ARM PrimeCell®
SRAM NOR + NAND Flash Memory Controller (PL353)
Errata Notice

This document contains all errata known at the date of issue in releases up to and including revision r2p1 of SRAM NOR + NAND Flash Memory Ctlr -3YT

501623: CS not deasserted in accesses to NAND in certain modes of operation**Status**

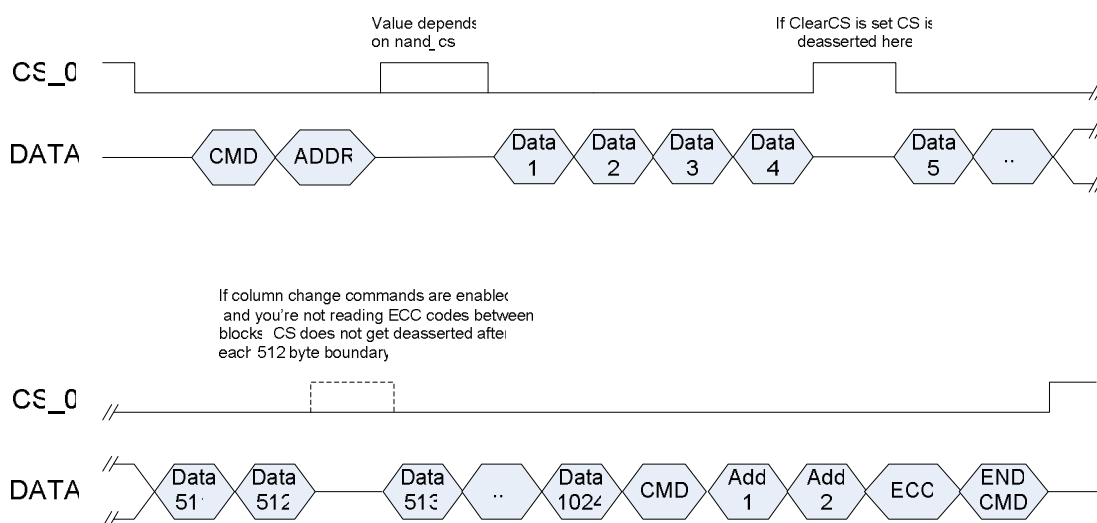
However, in certain modes of operation (specifically when column-change commands are enabled and you are not reading ECC codes between blocks), PL351/353 incorrectly assumes that it is about to perform an operation and cancels the request to ClearCS.

This results in **CS** not being deasserted after the last transfer in a 512 byte block and while **CS** is deasserted the EBI will not be released. The following timing diagram illustrates the **CS** behaviour.

Under the above mentioned conditions, **CS** will not be deasserted. This could result in a deadlock situation if data or code required to create the next transaction is stored through the same EBI.

If ECC is disabled, this problem will not occur.

When using ECC, there are two possible work arounds:

1. Use the ECC block in full command mode for writes, and read ECC codes between blocks for reads.

2. If you are reading or writing more than one 512 byte block, ensure that the data crosses the 512 byte boundary in a single un-interrupted transaction.
